NEW YORK STATE THRUWAY AUTHORITY
DEPARTMENT OF ENGINEERING

AMENDMENT NO. 1
TO

CONTRACT TAA 25-6B
D215009
REHABILITATION OF NYS THRUWAY (I-90)
BRIDGE OVER NYS ROUTE 5S / ERIE
CANAL RAIL TRAIL
AT MILEPOST 178.38
IN THE ALBANY DIVISION
IN MONTGOMERY COUNTY

| TITLE OF DRAWING GENERAL ROADWAY PLAN (SHEET 2 OF 3) | DRAWING NUMBER: GNP-02 |

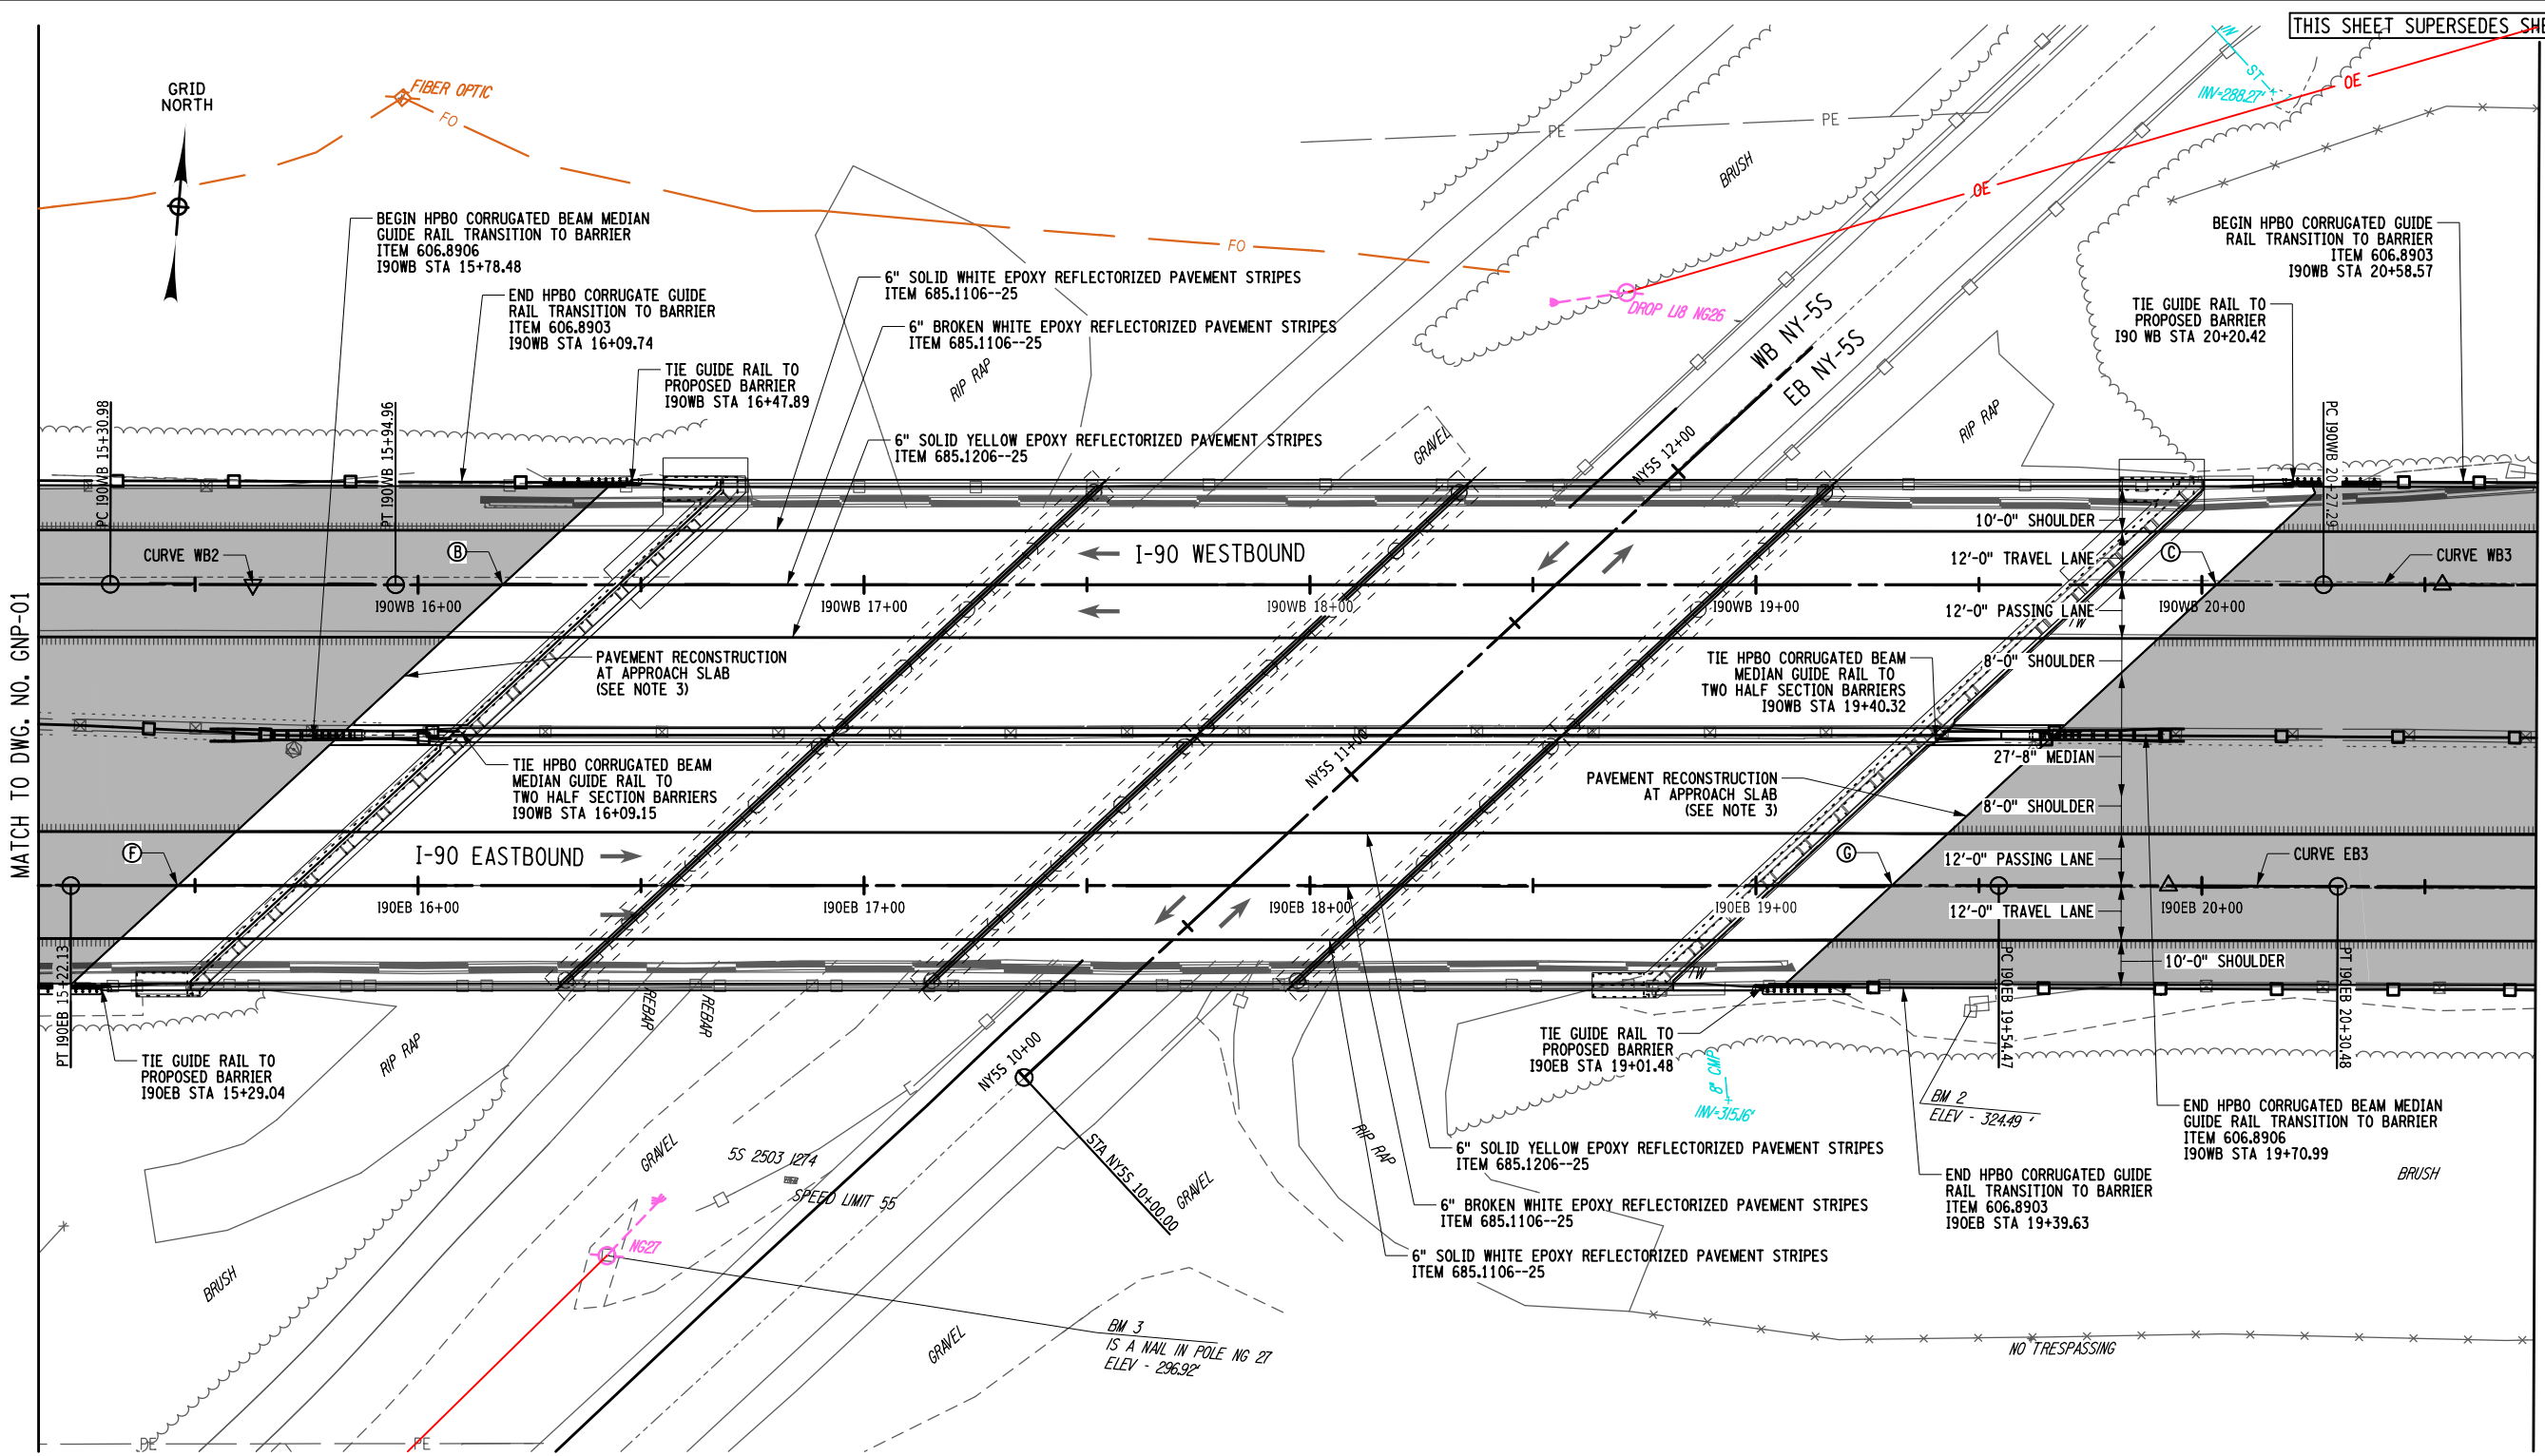
17. **DELETE** Drawing Number GNP-02, sheet 32 of 95, and **SUBSTITUTE** with the attached Drawing Number GNP-02, Sheet 32-A1 of 95. Note 3 was added to refer the reader to Drawing ST-42 for pavement reconstruction adjacent to the approach slab.

- NOTES:**
- SEE GNP-01 FOR CRITICAL STATION TABLE.
 - REMOVE AND REPLACE DELINEATORS IN KIND.
 ITEM 646.50: REMOVE AND DISPOSE DELINEATORS AND MARKERS.
 ITEM 646.0603--25: INSTALL DELINEATOR OR TENTH MILE MARKER ON POST.
 ITEM 646.0604--25: INSTALL DELINEATOR OR TENTH MILE MARKER, BACK-TO-BACK POST.
 - A SMALL AMOUNT OF PAVEMENT RECONSTRUCTION IS INCLUDED AT THE INTERFACE BETWEEN THE APPROACH SLAB AND ASPHALT TO ALLOW FOR INCREASED LIMITS OF EXCAVATION TO CONSTRUCT THE APPROACH SLAB. SEE DWG. NO. ST-42 FOR DETAILS.

| TITLE OF DRAWING PROPOSED ABUTMENT DETAILS (SHEET 1 OF 2) | | DRAWING NUMBER: ST-9 |

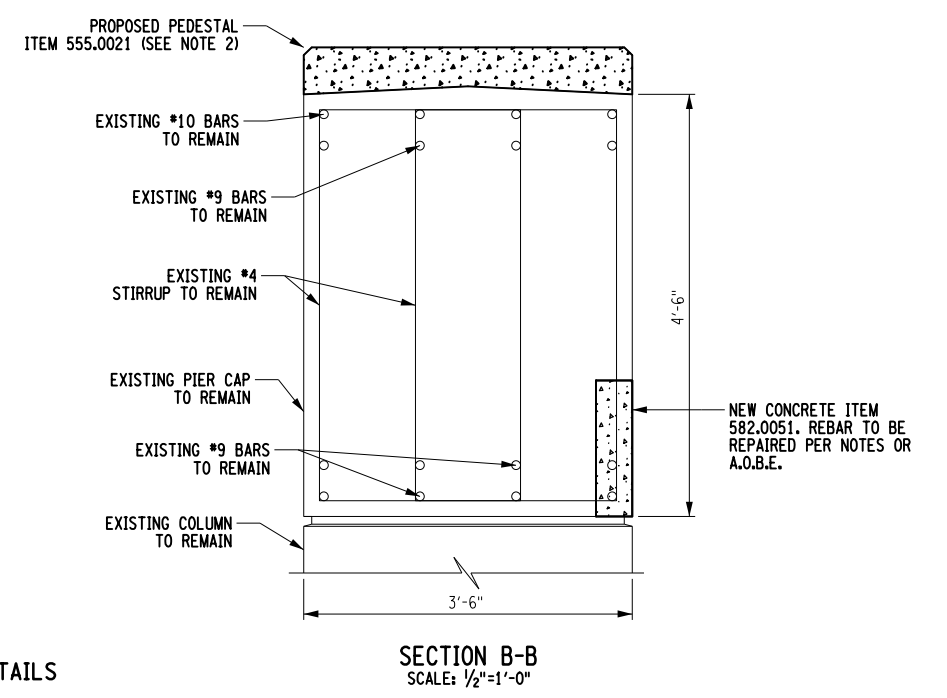
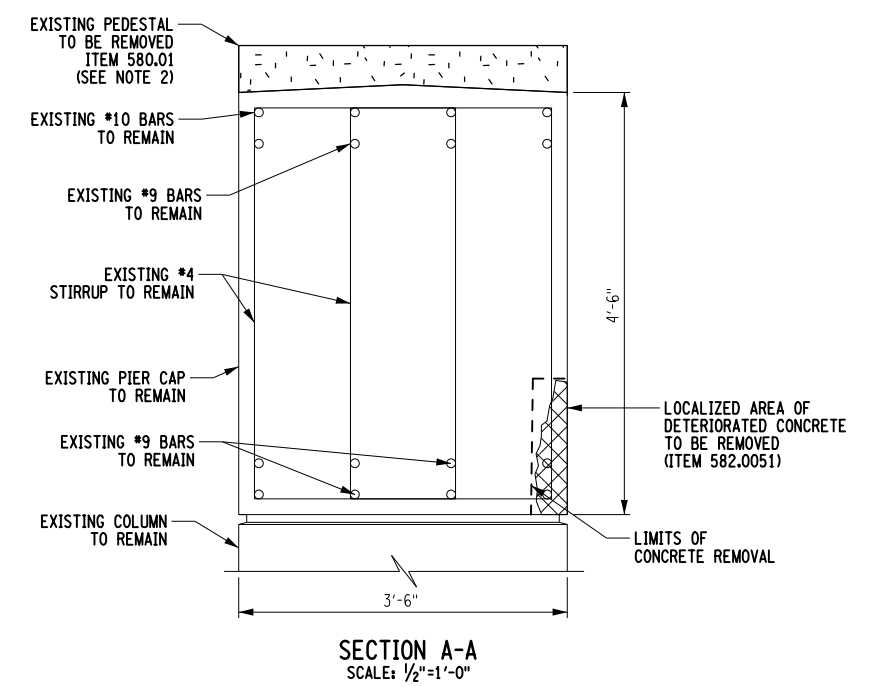
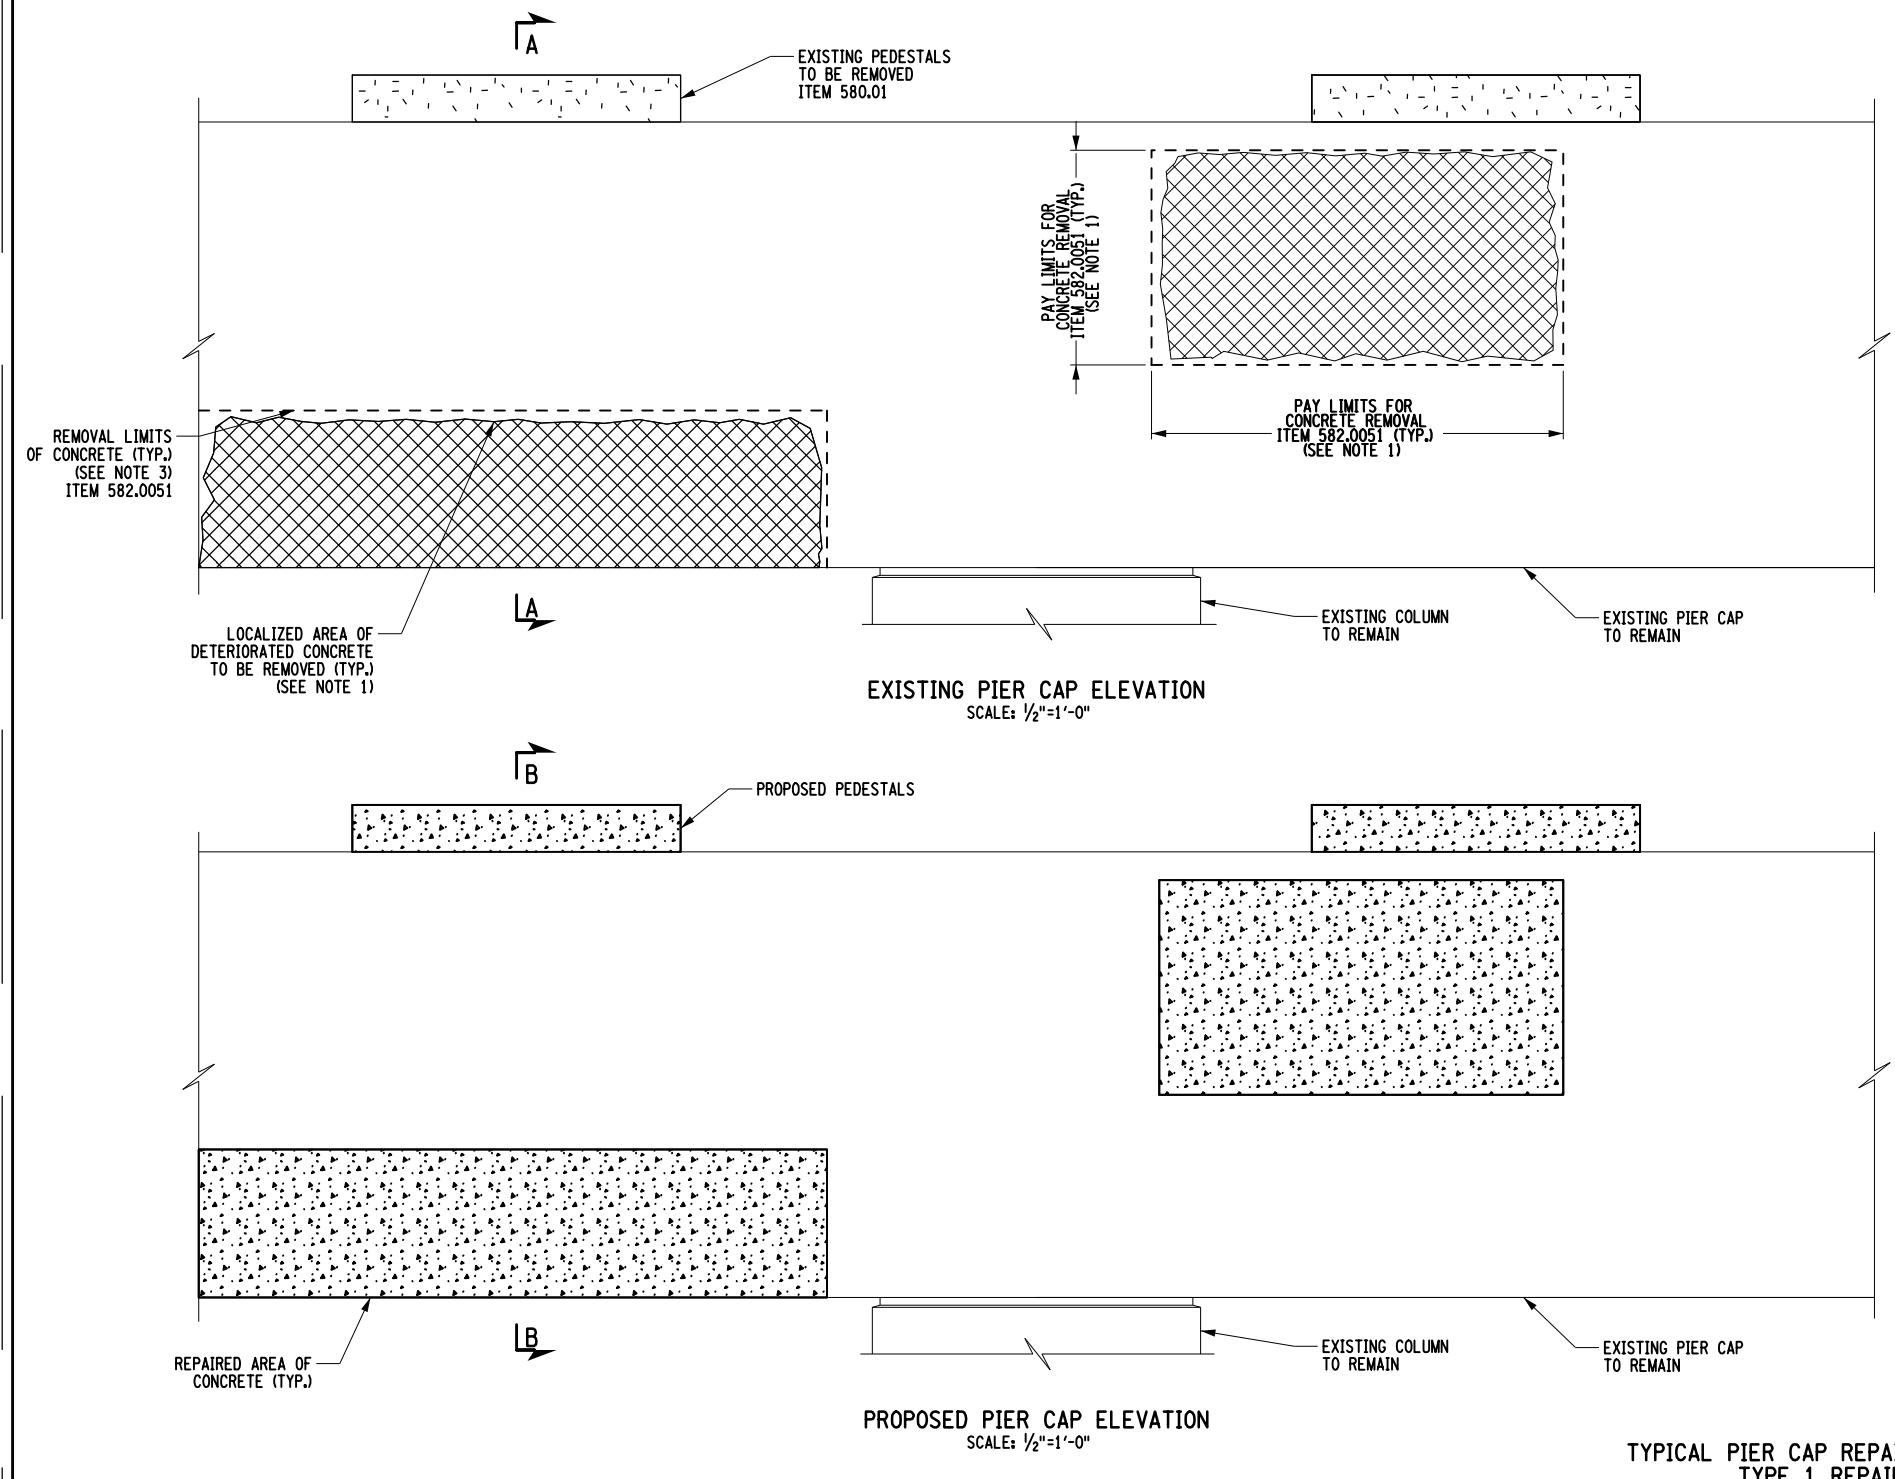
18. **DELETE** Drawing Number ST-9, sheet 49 of 95, and **SUBSTITUTE** with the attached Drawing Number ST-9, Sheet 49-A1 of 95. Note 5 was modified to reflect the use of standard item number 586.0201 for drilling and grouting reinforcing bars.

| TITLE OF DRAWING PEDESTAL DETAILS (SHEET 2 OF 4) | DRAWING NUMBER: ST-19 |

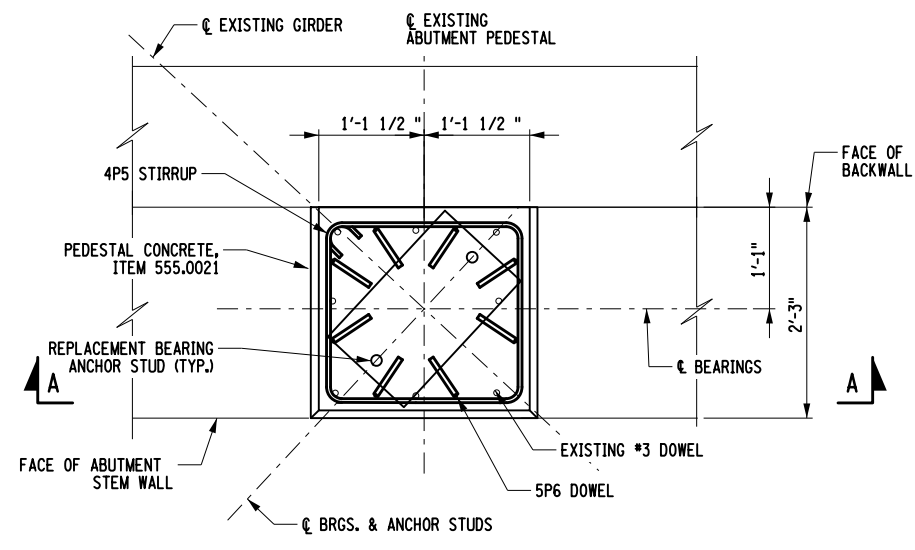
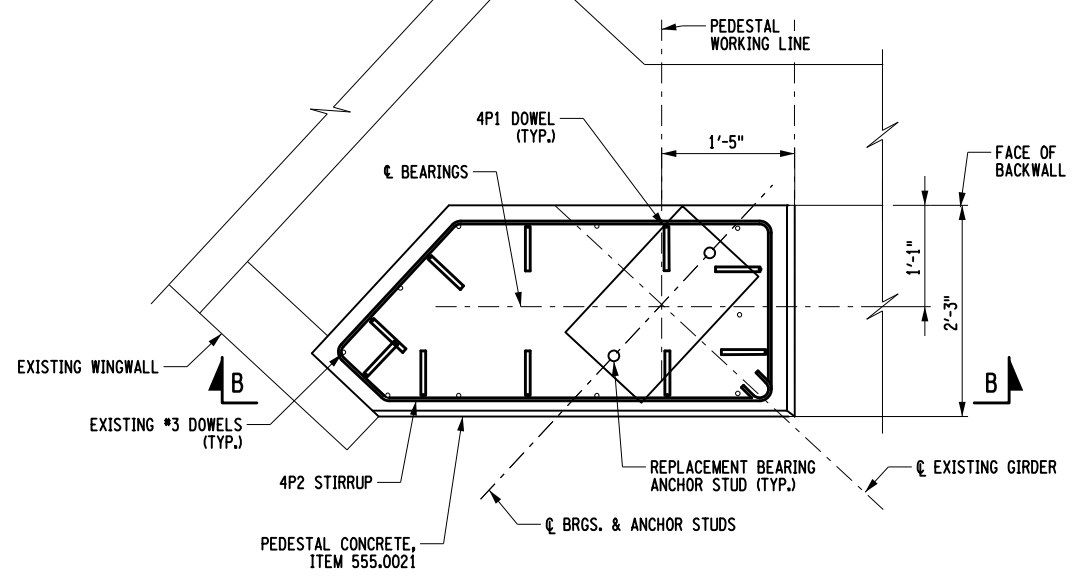
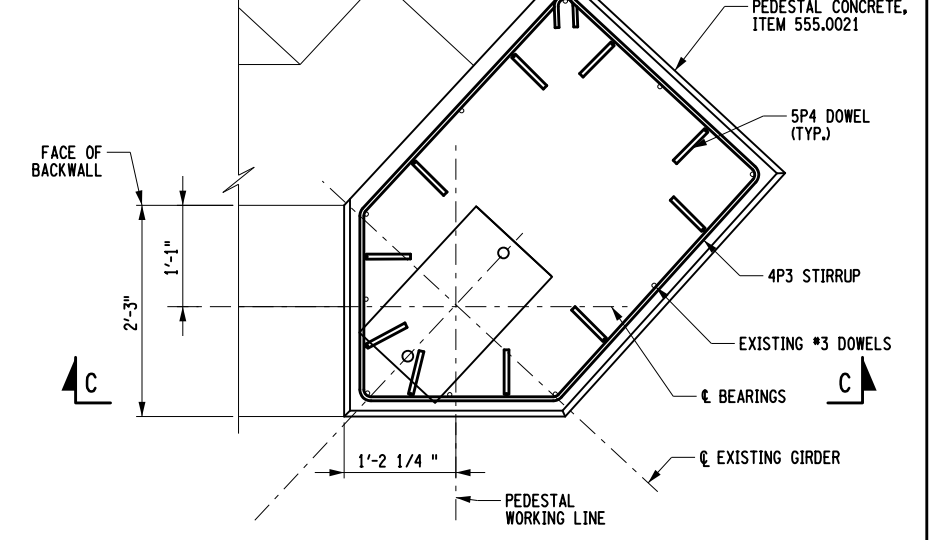
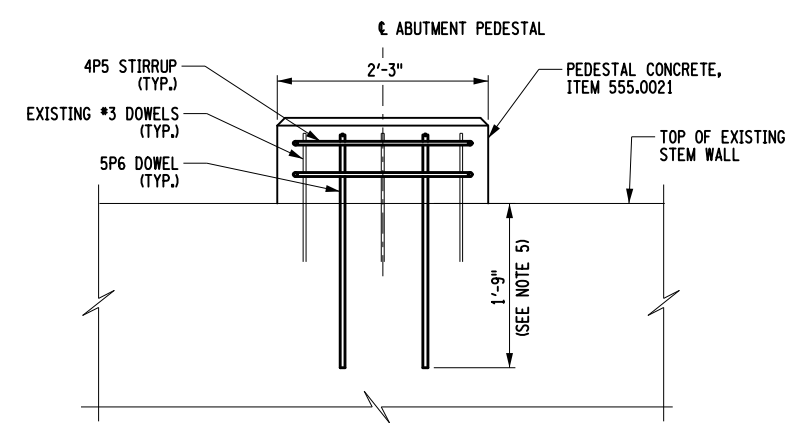
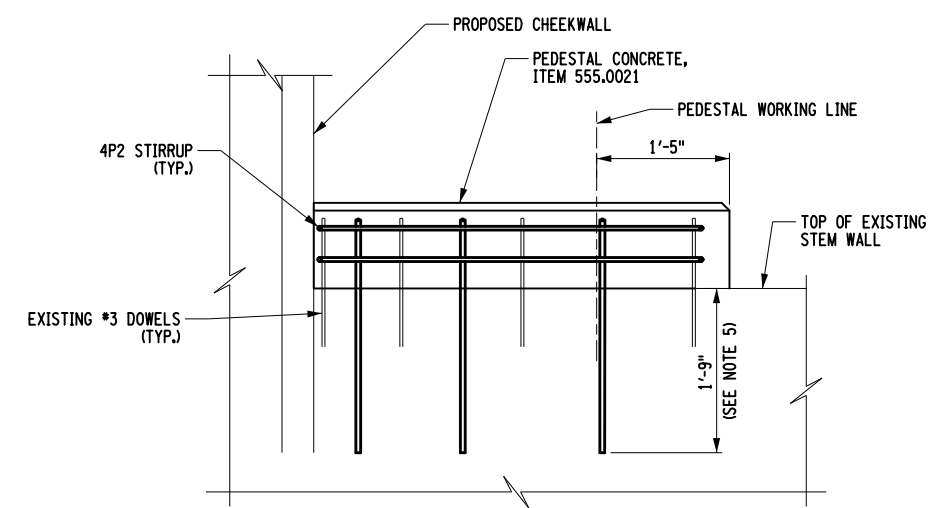
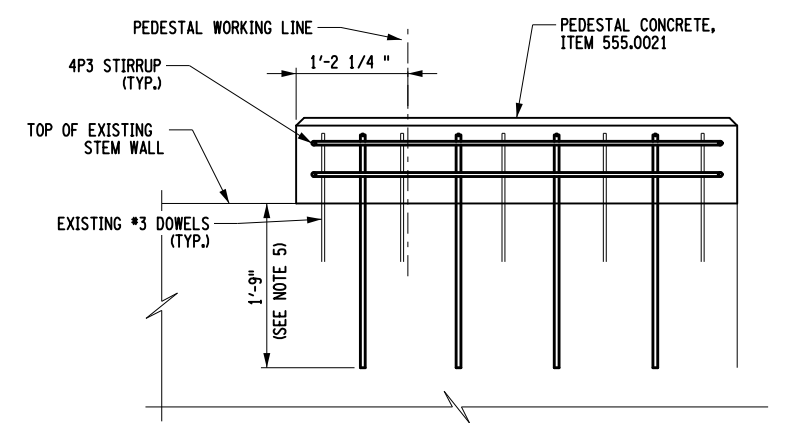
20. **DELETE** Drawing Number ST-19, sheet 59 of 95, and **SUBSTITUTE** with the attached Drawing Number ST-19, Sheet 59-A1 of 95. Note 5 was added to reflect the use of standard item number 586.0201 for drilling and grouting reinforcing bars.
